**CITY OF TEMPE  
DEVELOPMENT REVIEW COMMISSION**

**Meeting Date: 02/24/2015  
Agenda Item: 2**

**ACTION:** Request for a Development Plan Review consisting of two new apartment buildings containing 19 units, one Use Permit to allow tandem parking, and one Use Permit Standard to increase the maximum building height from 30' to 32' for 5<sup>TH</sup> & HARDY APARTMENTS, located at 1000 West 5th Street. The applicant is Anthony Miachika, Pacific Rim Property Investments Ltd.

**BACKGROUND INFORMATION:** 5<sup>TH</sup> & HARDY APARTMENTS (PL140327) will consist of two, three-story apartment buildings containing 19 units with both tandem and side-by-side garage parking. The request includes the following:

Building 'B' West Elevation

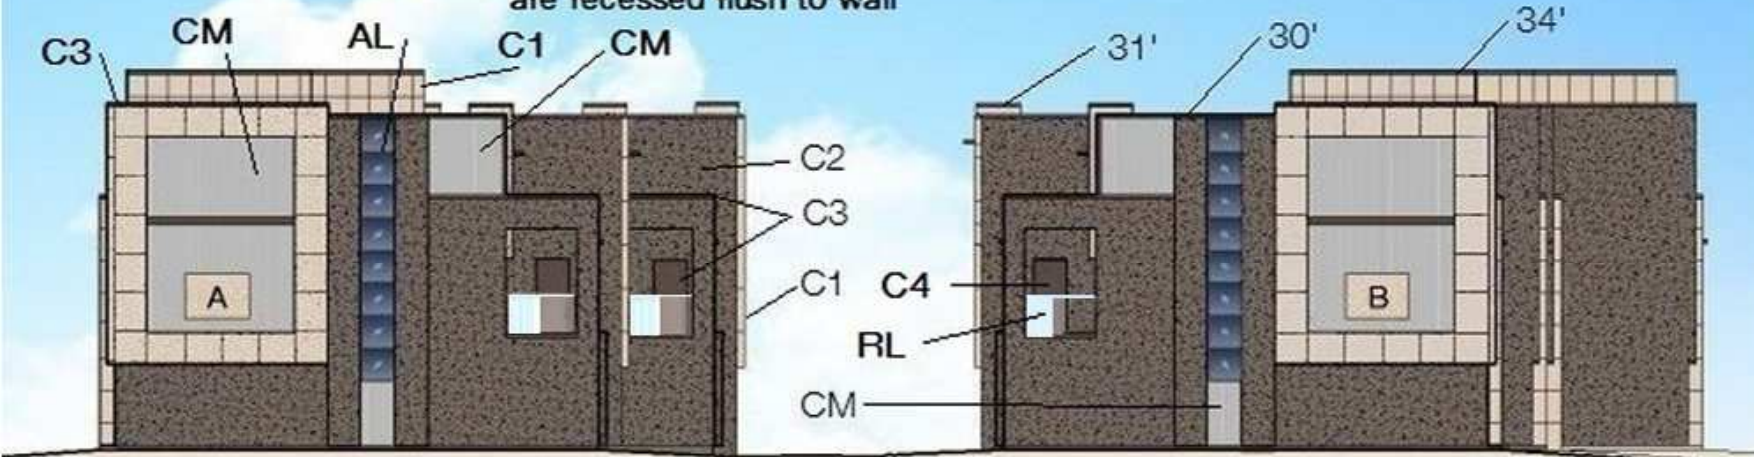
7. Where corrugated metal shares the same wall plane as stucco finishes, the metal shall be flush with the adjacent stucco walls.
8. The west elevations shall be modified to make all sides of the service entrance section (S.E.S.) flush with the adjacent wall.
9. All glass used on front doors and patio railings shall be laminated.
10. Provide secure roof access from the interior of the building. Do not expose roof access to public view.
11. Conceal roof drainage system within the interior of the building.
12. Incorporate lighting, address signs, and incidental equipment attachments (alarm klaxons, security cameras, etc.) where exposed into the design of the building elevations. Exposed conduit, piping, or related materials is not permitted.
